Clarifications for Test Frame for Suspended Components (12/03/2010)

The clarifications regarding bolt holes in the frame elements provided in this document supersede the details provided in the original drawings. The clarifications are provided in 5 drawings showing holes in the "Side Walls". The first three drawings, FR-A, FR-B, and FR-C, show "Typical", "Open", and "Link" side wall details, respectively. Each drawing presents the Front (view from outside the frame), End, Top and Bottom views of "Side Walls". The drawings, FR-D and FR-E, show schematic Edge Connections at the 4 corners and the 4 middle locations of the frame.

"Typical Side Wall" (x 6 req'd)

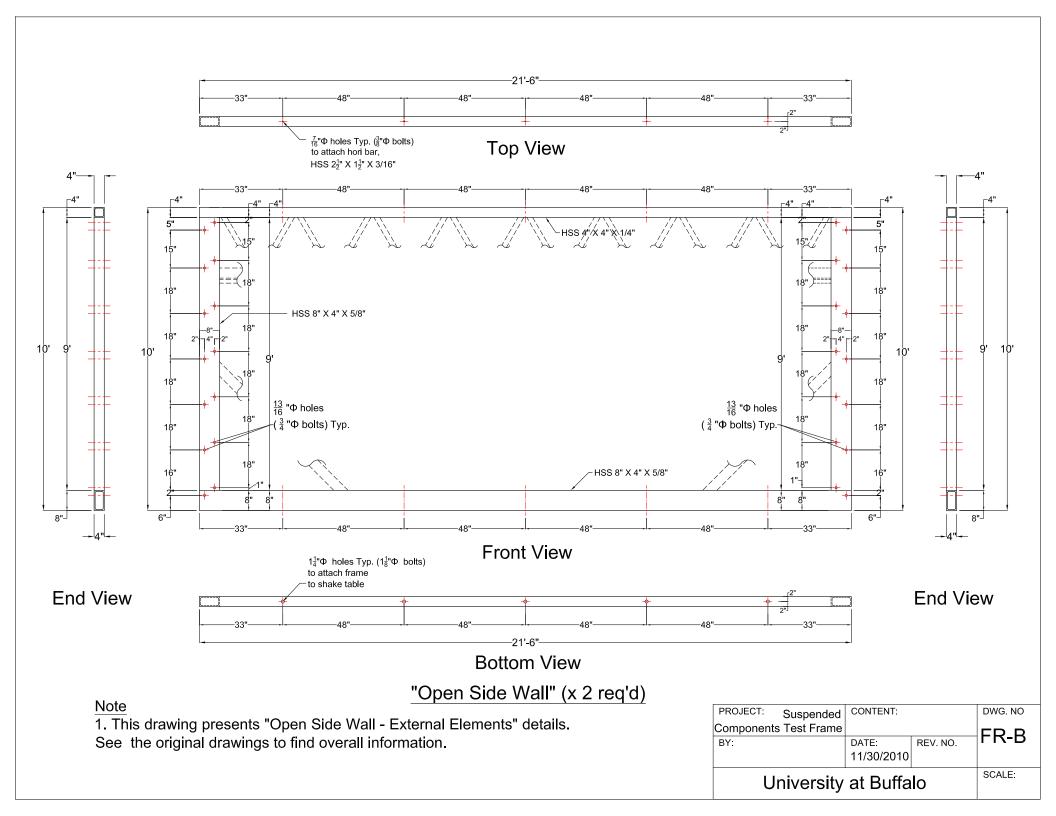
- The top holes $(\frac{13}{16})$ originally located at 2" in the external columns on the front surface were relocated at 5" from the top of the column.

- The holes locations in the end surface remain the same.
 - On the top bar of "Typical" and "Link" side walls, three holes at each designated location are required, instead of alternating one and two holes. The middle hole among the three is necessary for the installation of Horizontal Bars (HSS $2\frac{1}{2}$ "× $1\frac{1}{2}$ "× $3\frac{1}{16}$ ") at specified locations. The other two holes are necessary to attach Steel Joists (18K4). The precise size and location of the holes should be verified in field after measuring the prefabricated Steel Joist chord size.
